Enclosed for your information is one copy each of Project Interface Document (PID) Numbers 06-S-21, Revision 4, and 06-S-029, Revision 1. These PIDs are Class II changes. PID 06-S-21, Revision 4, provides for construction of a new wastewater retention basin at the New Rifle processing site and PID 06-S-029, Revision 1, eliminates the slurry wall at the New Rifle processing site.

PROJECT INTERFACE DOCUMENT (PID)

Site Rifle	Date 18 January 1994	PID No. 06-S-29, Rev. 1	Site No. 06	Vic. Prop. No.
Originator and Location G.G. Cherrington, SF, CA	Phone 415/442-7690	Organization MKS	Answer By:	References: Subcontract: Subcontract No:
Subject Elimination of Slurry Wall at New Rifle Processing Site

Site Rifle	Date 18 January 1994	PID No. 06-S-21, Rev. 4	Site No. 06	Vic. Prop. No.
Originator and Location G.G. Cherrington, SF, CA	Phone 415/442-7690	Organization MKES	Answer By:	References: Subcontract: Subcontract No:
Subject Revision of Subcontract Dwg. No. RFL-PS-10-0710 for Construction of an additional Wastewater Retention Basin at New Rifle Processing Site

FIGURE 1

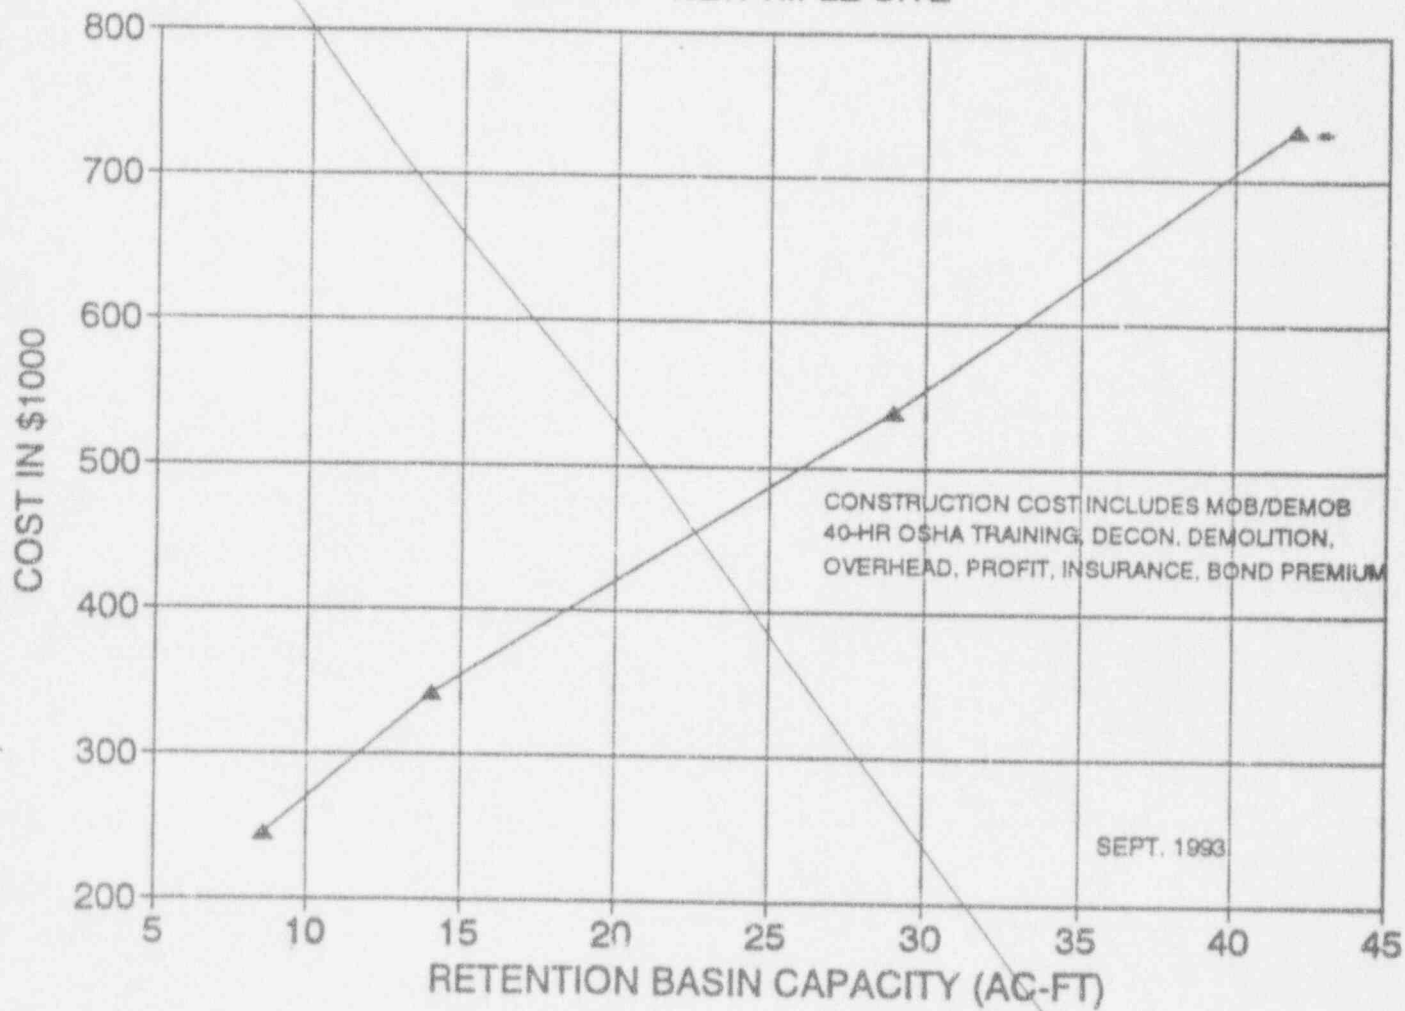
Delete
